**Re: Supplemental Submission – Revised Site Plans
Proposed Mixed Use Development, Russell & Deer Street, Portsmouth, NH**

NORTH END MIXED USE DEVELOPMENT

LAST REVISED SEPTEMBER 28, 2022

**TAC RESUBMISSION
COMPLETE SET 42 SHEETS**

OVERALL SITE PLAN

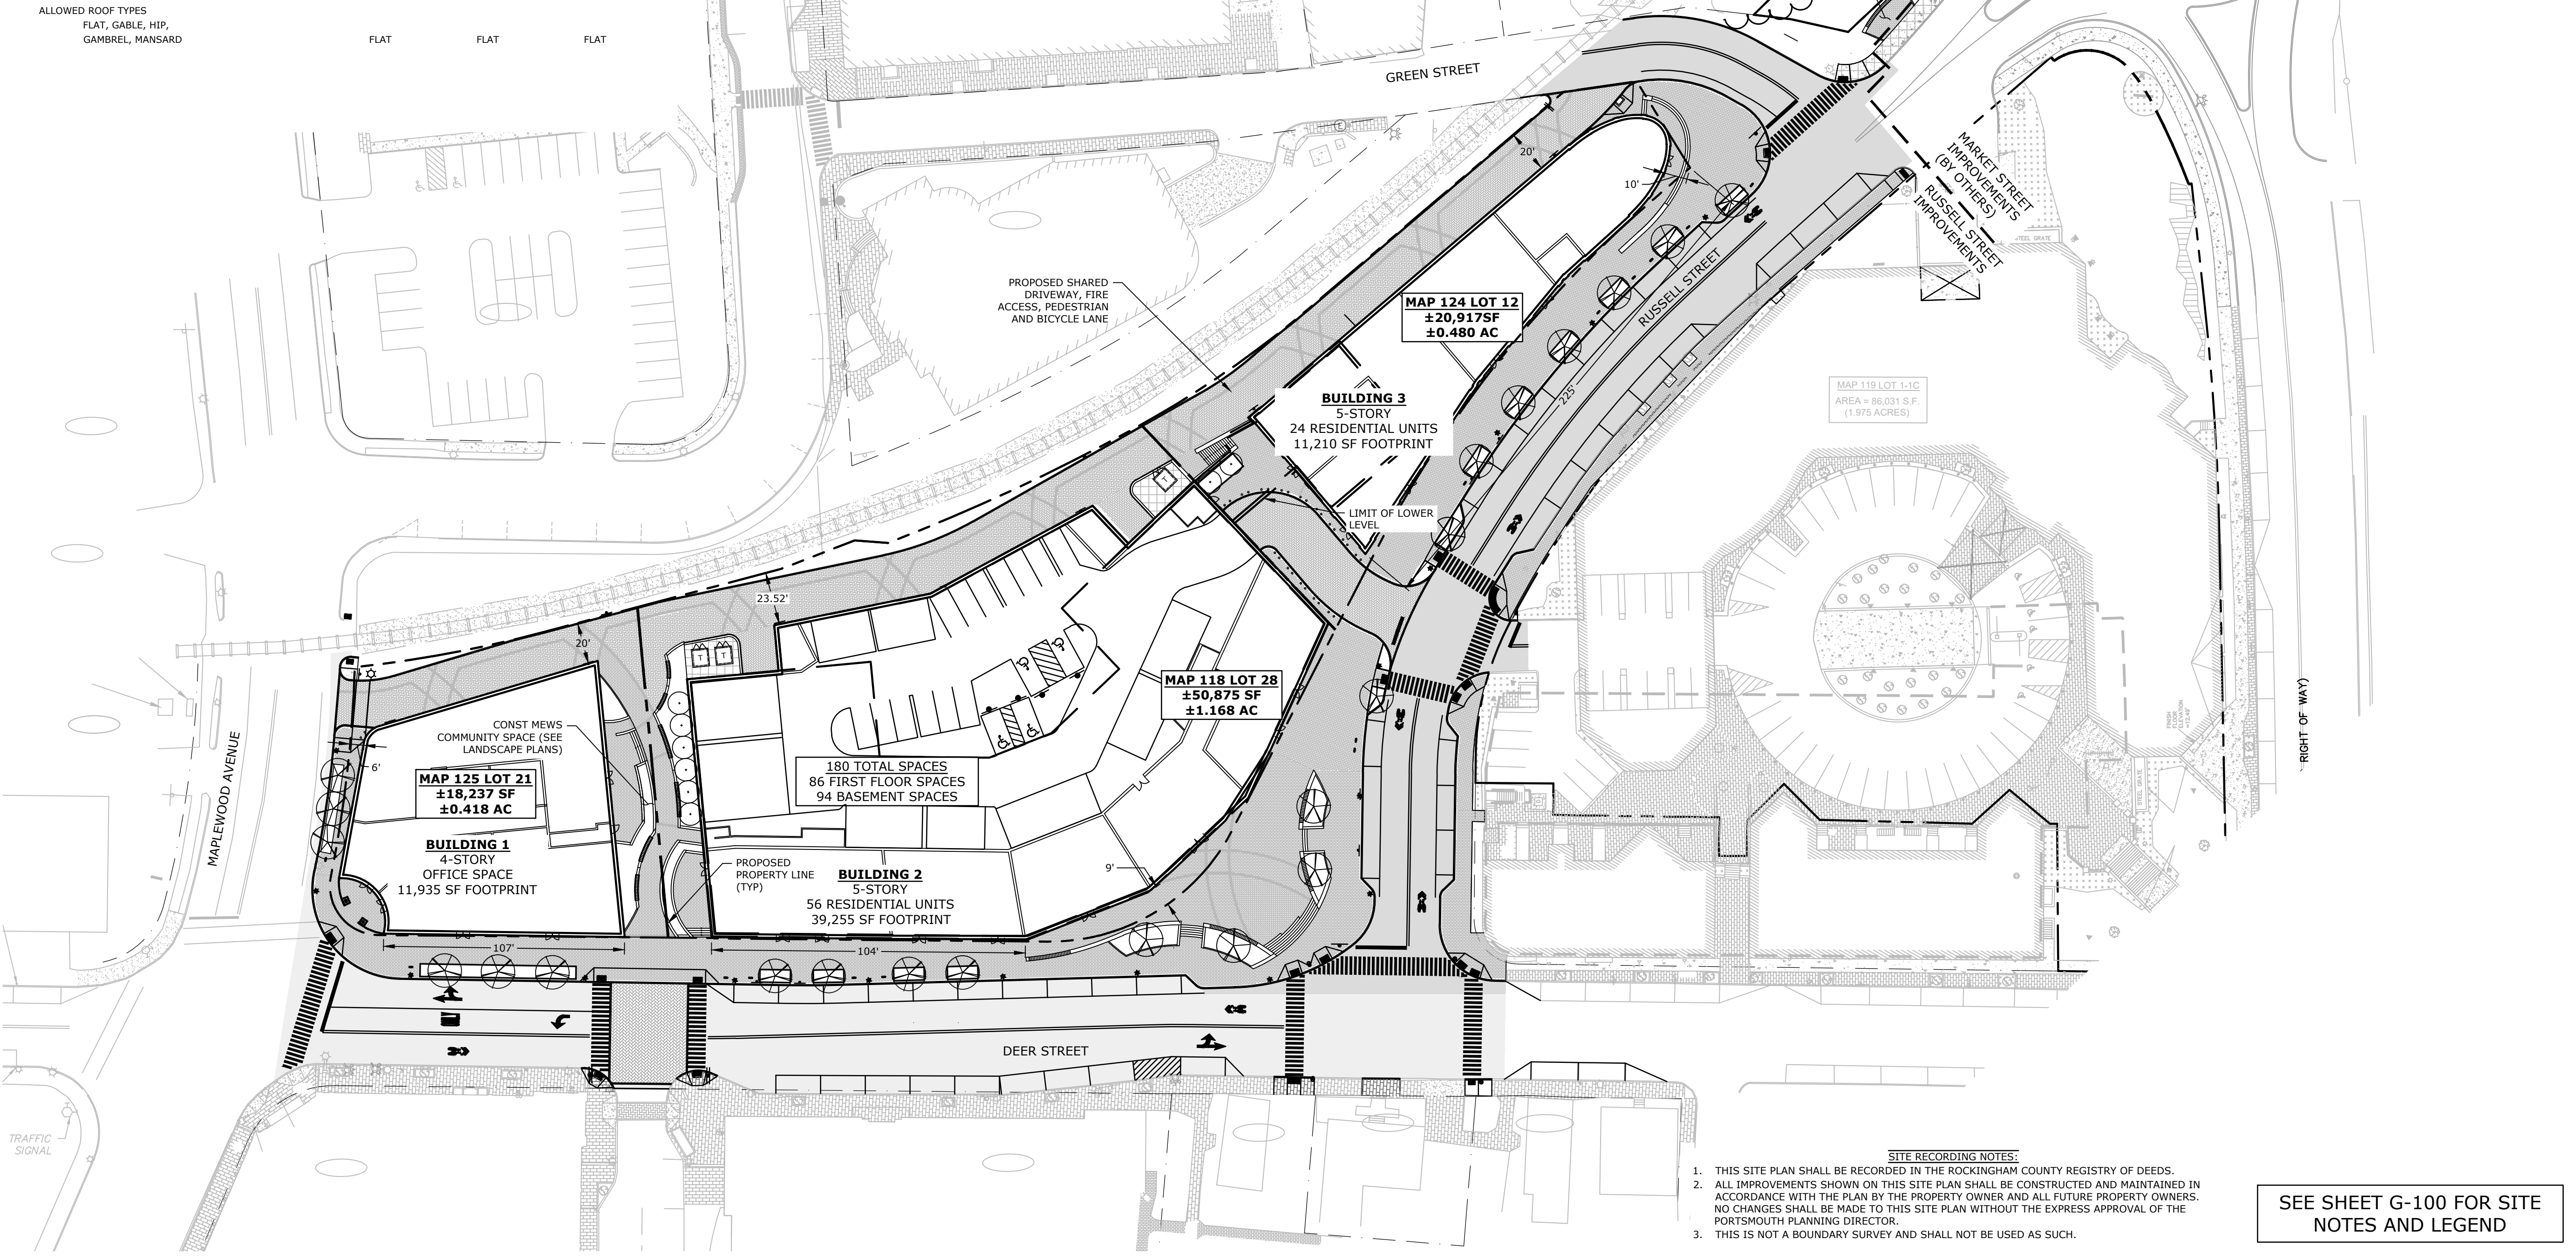
30	The grease traps in the driveway to the garage are not located well. They need to be on the sides so that the driveway can still be used during cleaning.	The grease traps have been moved as close to the edge of the driveway as much as feasible. The upper driveway will be used mostly by the hotel valet, who will be able to work around any restrictions.	C-104
31	The Russell St water main will need to be relocated out from under the plaza and proposed trees.	See comment 18.	C-104
32	Vertical curb shall be 6" width.	VGC detail is 6" wide.	C-503
33	Bricks shall be tight joints not 'finger tight'.	All Paver details have been modified to call out tight joints rather than finger tight joints.	C-502
34	Cast iron HC panels shall be radiuses or rectangular as appropriate and determined by DPW.	Cast iron detectable warning panel detail has been modified to include radiuses panels.	C-502
35	Both sidewalks on Russell shall be brick	The sidewalk on the Sheraton side of Russell Street has been modified to include the demolition of the existing concrete sidewalk and the construction of a brick sidewalk.	C-102 & C-102.1
